V2500-A5/D5 PROPULSION SYSTEM SERVICE BULLETIN

This document transmits Revision 1 to Service Bulletin EV2500-73-0180

ENGINE FUEL AND CONTROL – FUEL METERING UNIT – INTRODUCTION OF A WOODWARD AIRCRAFT
ENGINE SYSTEMS (WAES) FMU WITH REVISED FUEL METERING VALVE (FMV) SERVOVALVE
TORQUEMOTOR STOPSCREWS

**ENGINE FUEL and CONTROL - FUEL METERING UNIT (FMU) - Incorporation of
Modified Fuel Metering Valve (FMV) Servovalve.**

Family Tree
Fig.1

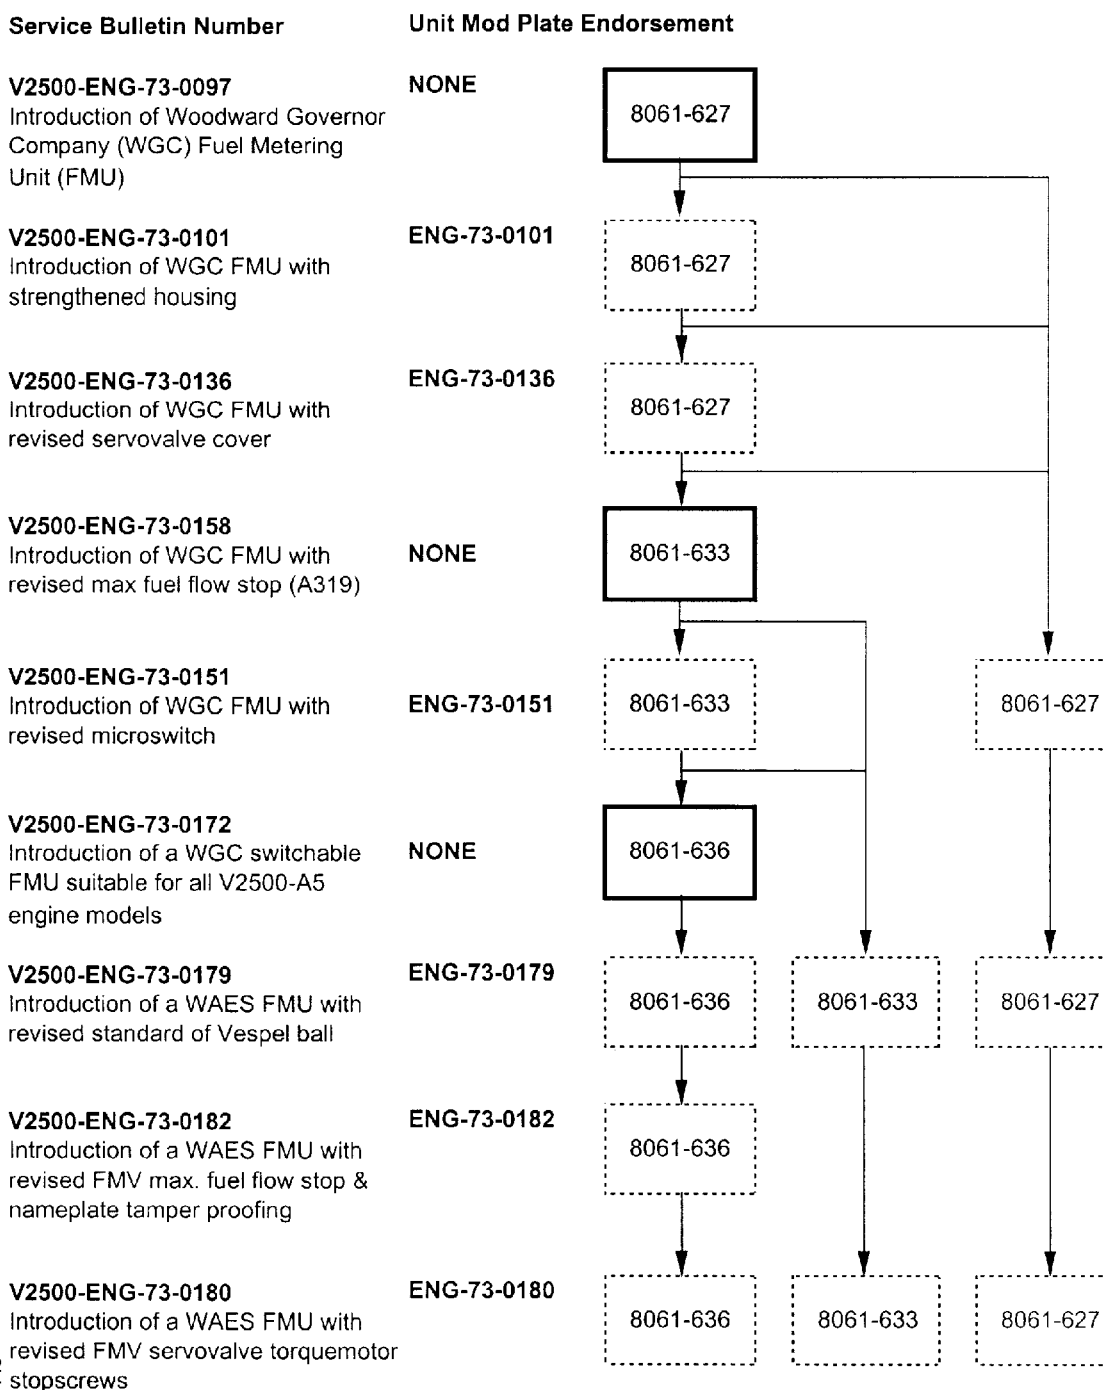
V2522-A5 and V2524-A5 FMU Family Tree *

Family Tree
Fig.2

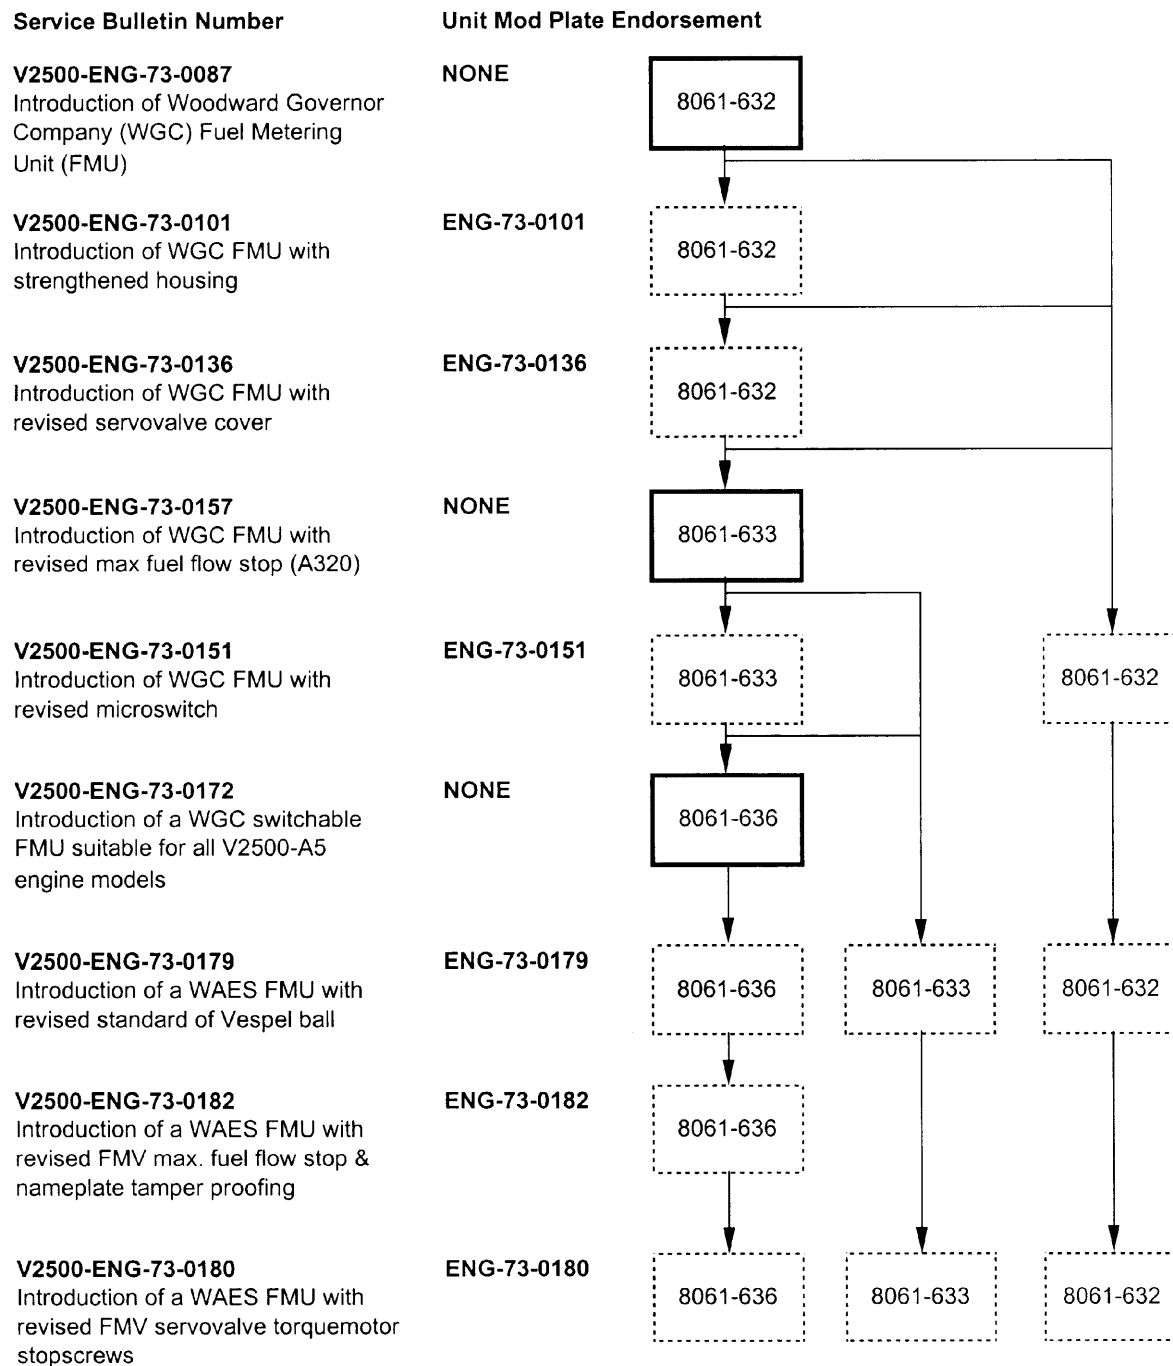
V2527-A5 and V2527E-A5 FMU Family Tree *

Family Tree
Fig.3

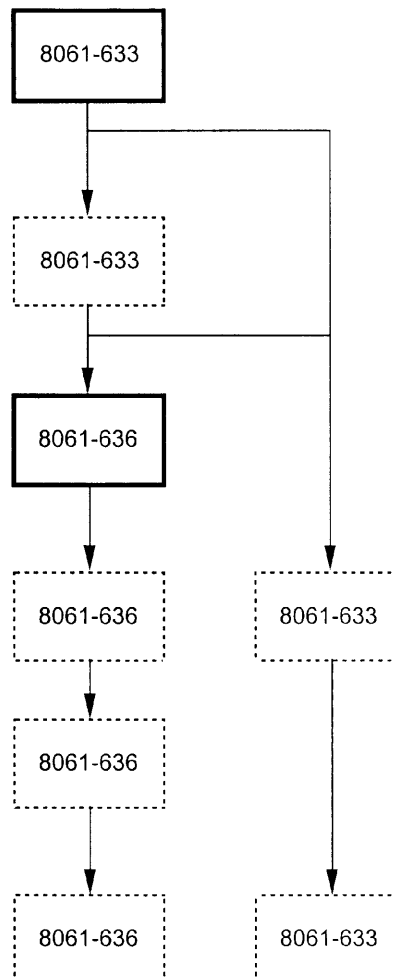
**V2527M-A5 FMU Family Tree *****Service Bulletin Number****Unit Mod Plate Endorsement****V2500-ENG-73-0158**

Introduction of a WAES FMU with revised FMV servovalve torquemotor stopscrews

Family Tree
Fig.4

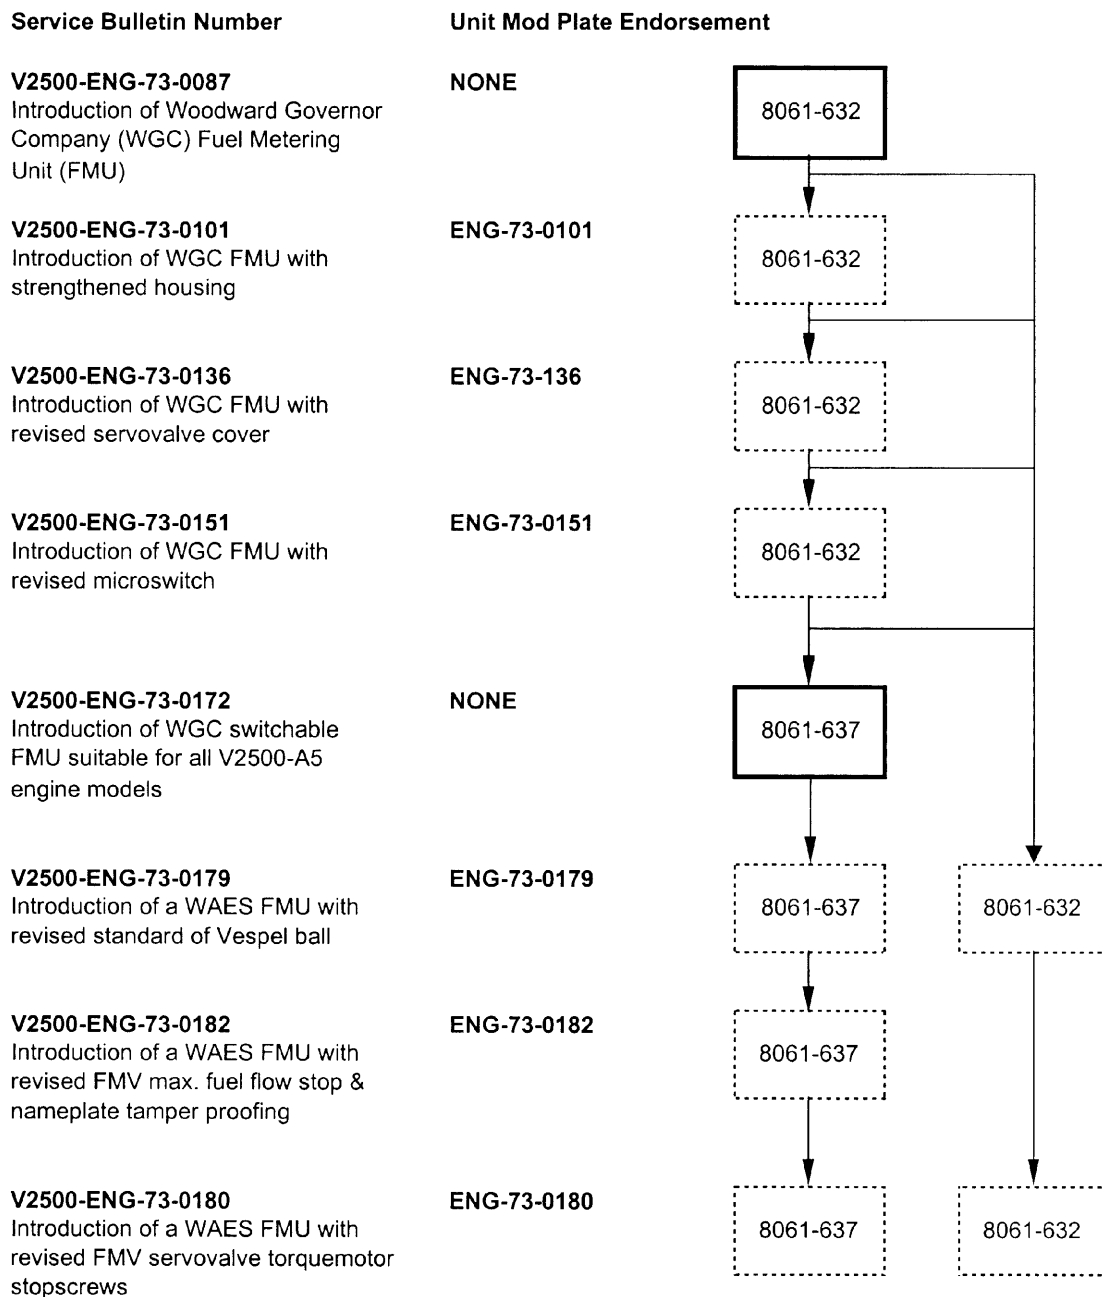
V2530-A5 and V2533-A5, FMU Family Tree *

Family Tree
Fig.5

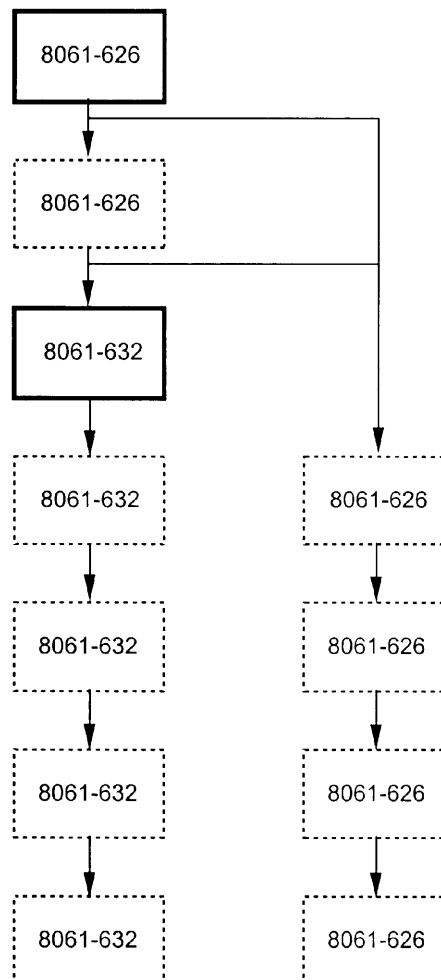
**V2525-D5 and V2528-D5 FMU Family Tree *****Service Bulletin Number****Unit Mod Plate Endorsement****V2500-ENG-73-0085**

Introduction of a WAES FMU with revised FMV servovalve torquemotor stopscrews
